IEEE P 802.20™/PD<insert PD Number>/V<6>

Draft 802.20 Permanent Document

<802.20 Requirements Document - Rev 6>

This document is a Draft Permanent Document of IEEE Working Group 802.20. Permanent Documents (PD) are used in facilitating the work of the WG and contain information that provides guidance for the development of 802.20 standards. This document is work in progress and is subject to change.

Figure 1—IEEE 802 RM for end stations (LAN&MAN/RM)

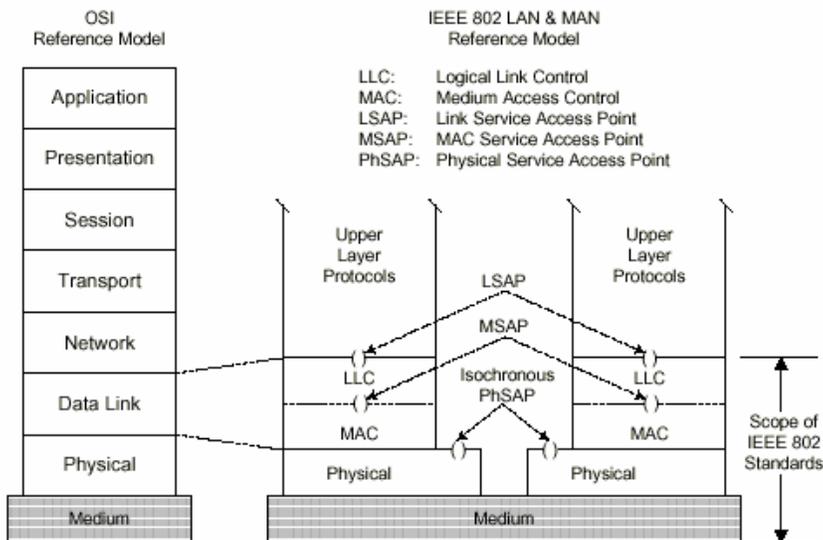
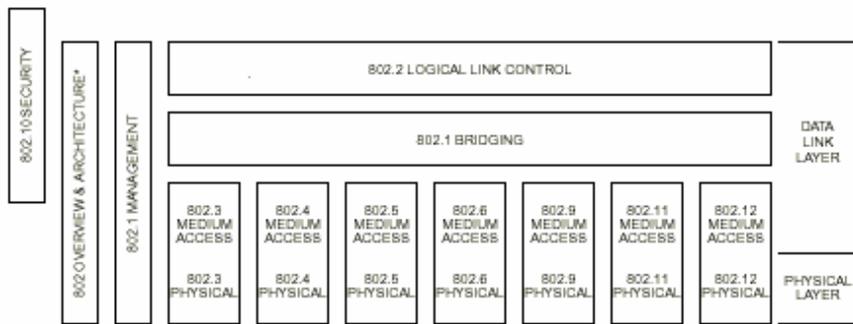
7 I propose to adopt the MBWA-Specific Reference Model and its
8 explanation from the attachment, that will replace 5.1.1.

11
12 - 802.1 bridging, in Fig. 2, is actually beyond the standard;
13 including it in the standard scope will make the radio behave as a
14 Ethernet bridge and will have implications in frame headers (look at
15 802.11 MAC, carrying if I remember well, up to four Ethernet addresses
16 in the frame header);

17
18 - 802.1 Management, in Fig. 2 is actually insufficient for access
19 systems, being suitable only for LAN and WLAN systems;

20
21 - Security functions are not shown;

22
23 - Management functions and their interaction with
24 MAC/PHY/Security is not shown;

25
26 - PHY interaction with the radio deployment is not shown.

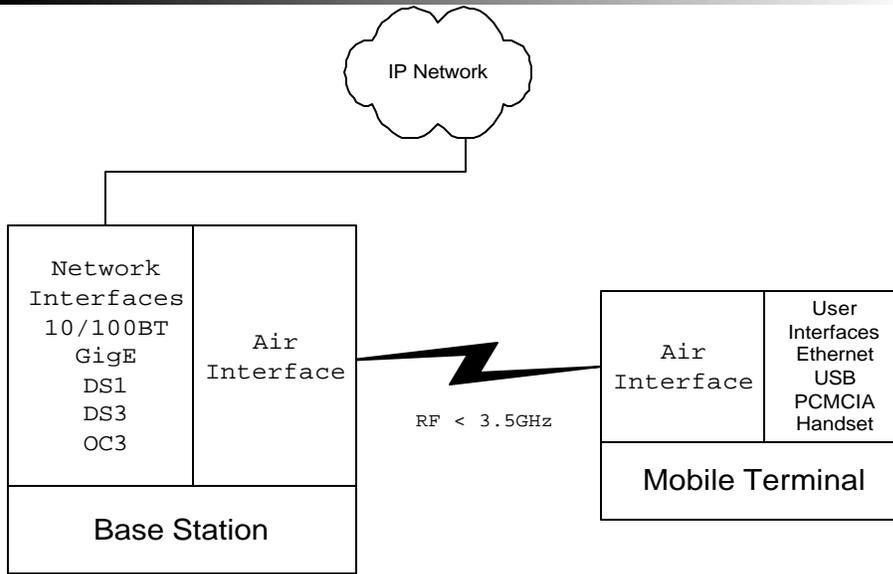
14 [Action: Change the notations in the bubbles to point to the relevant](#)
15 [section of the text \(or remove the bubbles\).](#) <John Fan 7/23/03>
